SI0289

Equipment Affected: YCAS, YCWS, and YCRS

New Style Motor Protection Model

035-15164-301 System 1

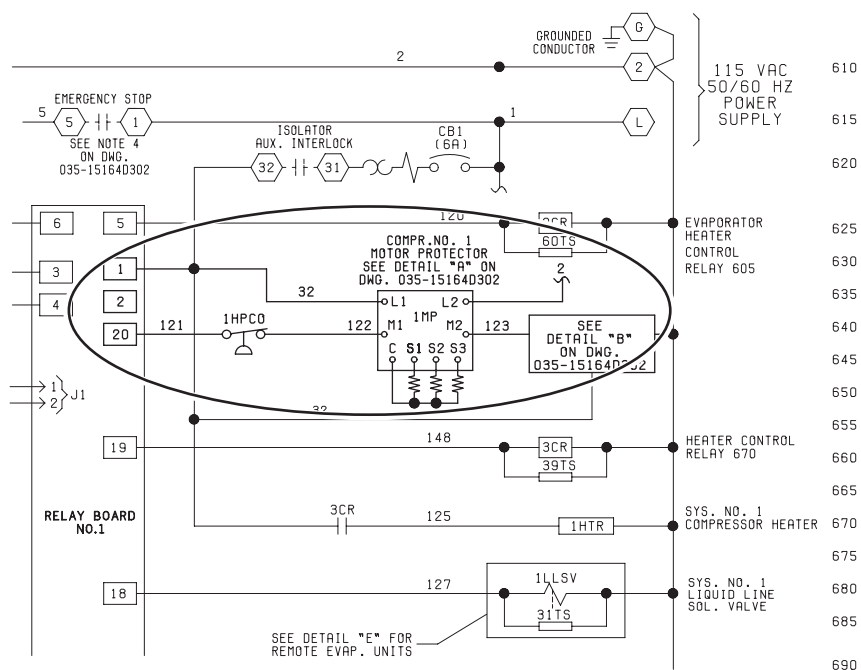
SYSTEM 1 - 120VAC, RELAY PCB 1
WIRE 32 AND WIRE 2

1. New compressor needs a 270 Ω resistor across S1, S2, S3 (in series)
2. New compressor thermistors will read 50-60 Ω
3. Old compressors or remanufactured Compressor thermistors will read 12 -1,500 Ω
4. New MPM are 120VAC
5. C.T. plus wire goes to the plus on J4 and the minus goes to the minus on J4 (See Elementary Drawings)
6. C.T. jumper to be set on the HIGH SETTING.

035-15164-301 System 2

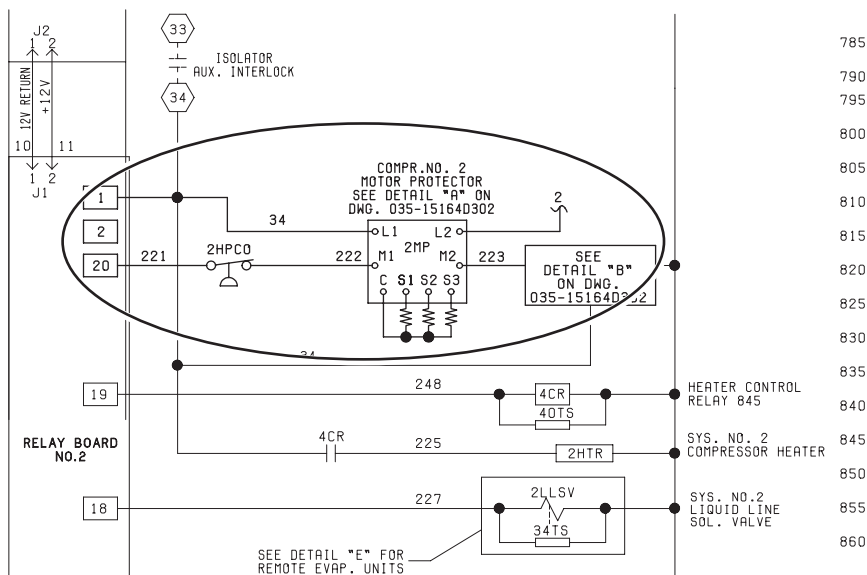
SYSTEM 2 - 120VAC, RELAY PCB 2

WIRE 34 AND WIRE 2

NOTE: Wire numbers may/will change on these schematics depending on the product and the new M.P.M. is being installed on location and wiring points stay the same.
